28 June 2017
WTJ17-87

Section 96(1A) Modification Application (SSD 7917) – MOD 1

Horsley Drive Business Park, Lot 3, Burilda Close, Wetherill Park (Lot 5 DP 1212087)

Figure 1: Approved Layout

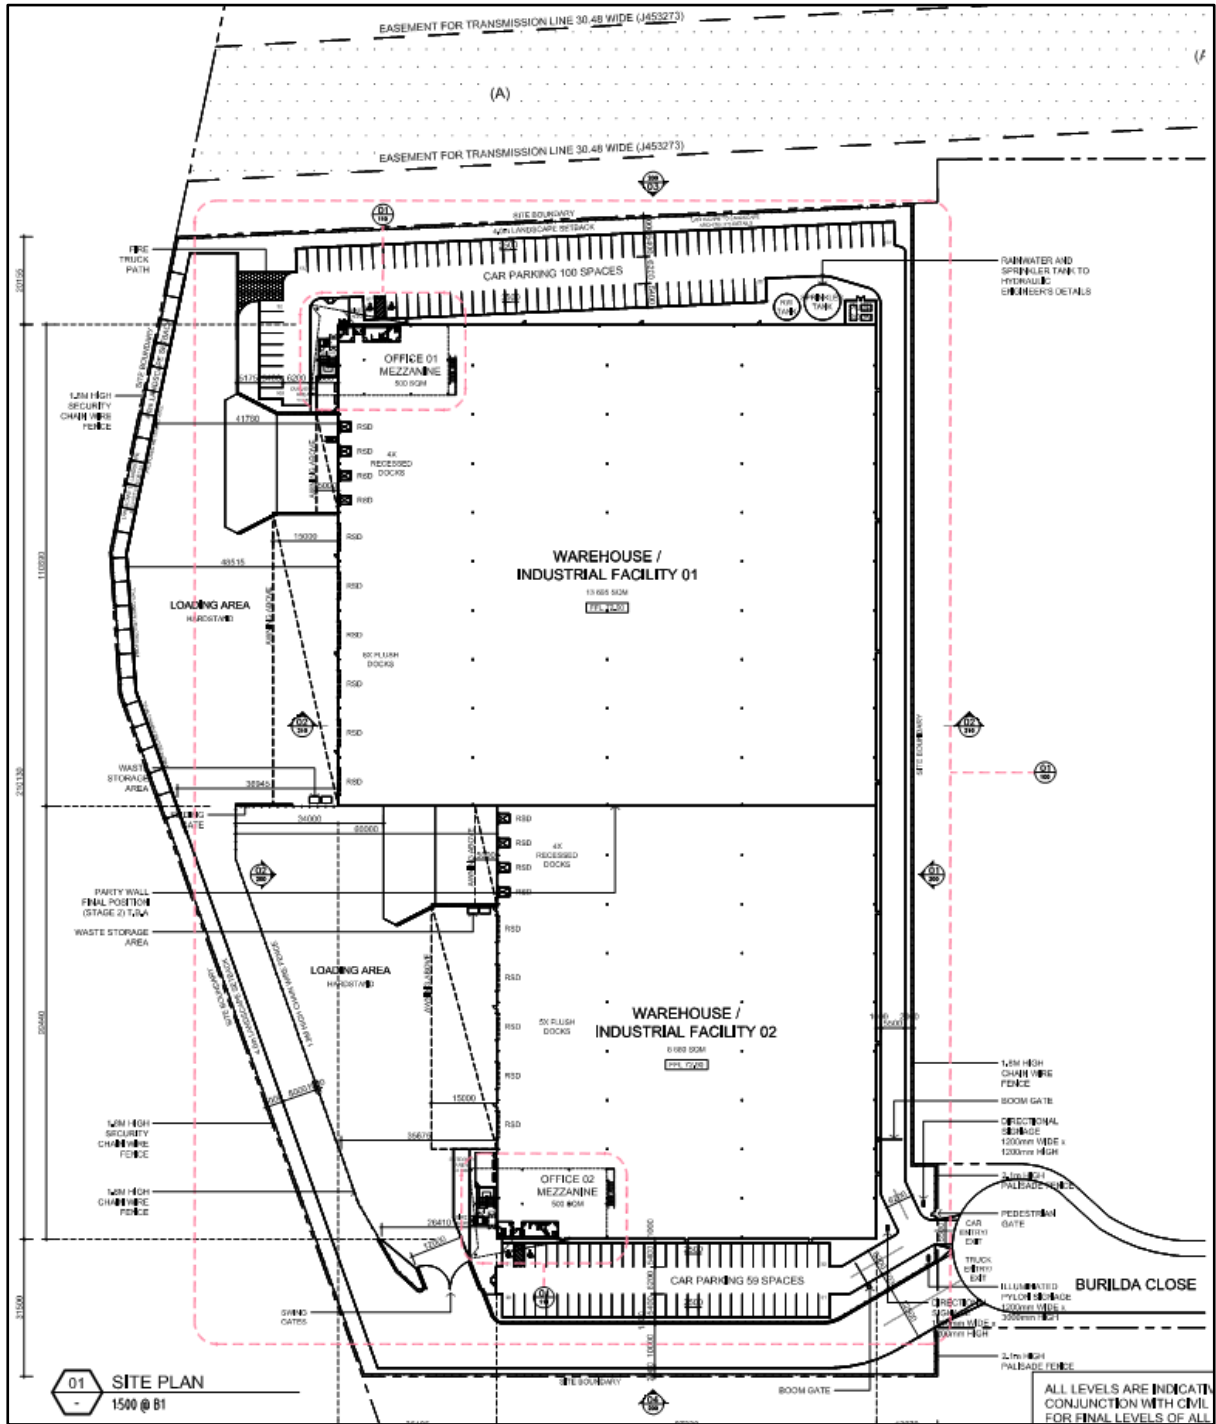
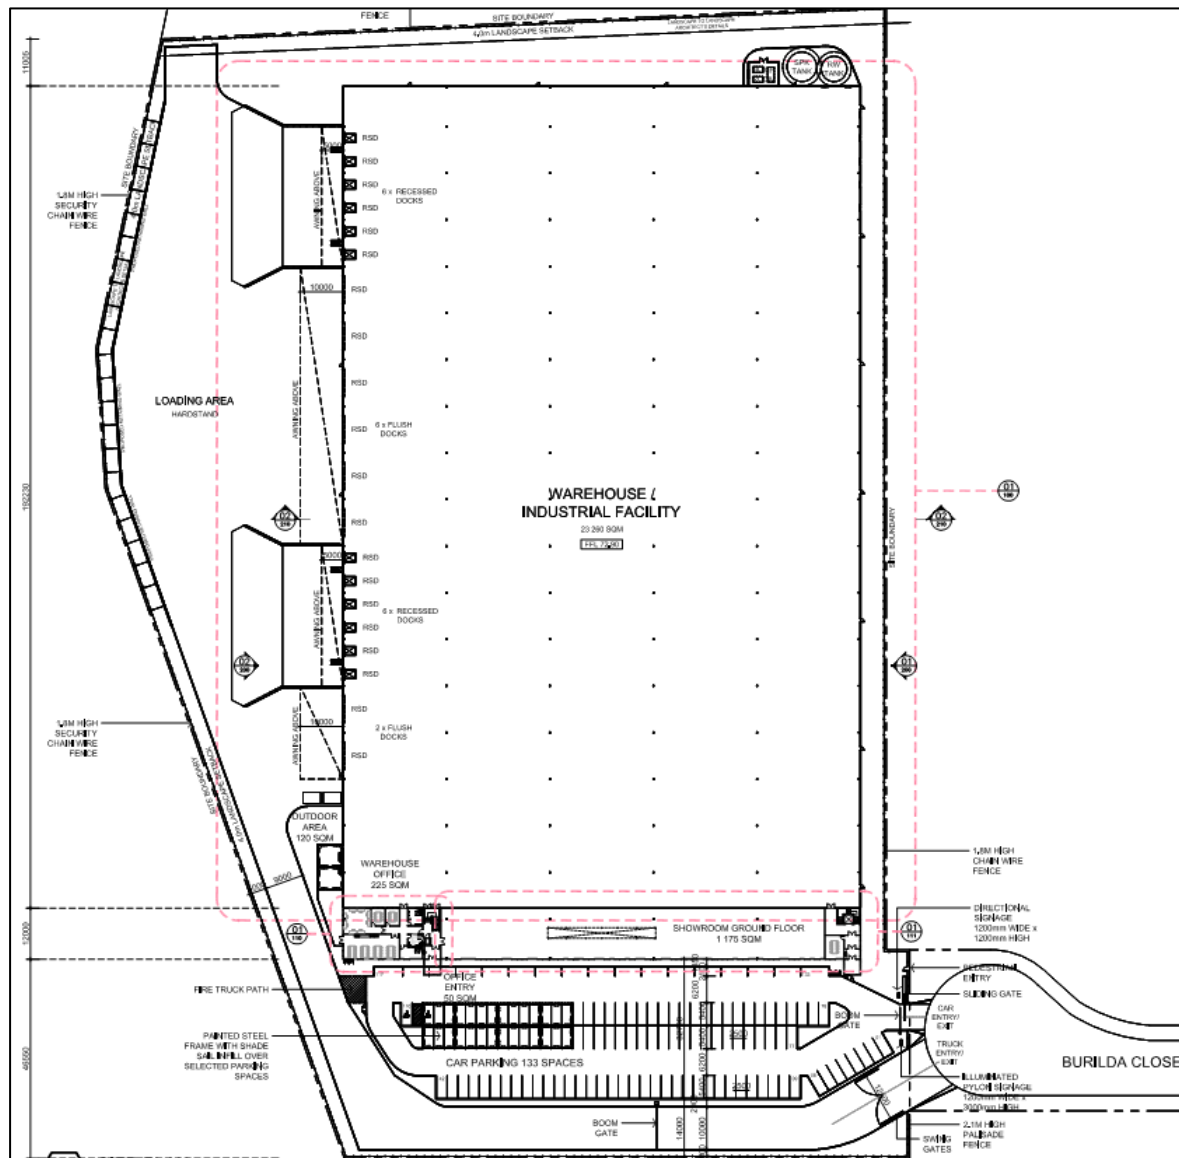
The proposal seeks modifications to SSDA 7917 and reflect post approval design changes to maximise the functional layout of the building for one future tenant. In summary, the modifications comprise of the following:

- Amalgamate the two (2) approved tenancies into one (1) warehouse/distribution facility.
- Align the warehouse office, showroom and office including a minor increase in height from 10m to 11.5m.
- Increase the Gross Floor Area (GFA) of the warehouse by +2,600m².
- Relocate office and office entry to the west end of the building.
- Relocate undercover parking spaces to the west end of the car park.
- Addition of a meeting room and secure lobby to the showroom entry on the ground floor.
- Addition of a void at the first floor to allow occupants to look down to the ground floor below.
- Relocation of outdoor area.
- New direct access from main office to showroom and warehouse office.
- Glazing from main office into warehouse from the open work areas, meeting rooms and circulation stair.

Table 2: Schedule of Proposed Changes		
Project Element	Approved	Proposed under Section 96
Warehouse	<ul style="list-style-type: none">- Warehouse 1 – 13,695sqm GFA; Office – 500sqm GFA; Ground Floor Entry – 40sqm;- Warehouse 2 – 8,680sqm GFA; Office – 500sqm; Ground Floor Entry – 40sqm; <p>Total Building Area = 23,455sqm.</p>	<ul style="list-style-type: none">- Warehouse – 23,260sqm GFA; Showroom (2 Storey) – 1,990sqm; Office – 530sqm GFA; Office Entry – 50sqm; Warehouse Office – 225sqm. <p>Total Building Area = 26,055sqm.</p>
Site Area	43,976sqm	43,976sqm
Car Parking	159 spaces	133 spaces

Figure 2: Proposed Site Plan
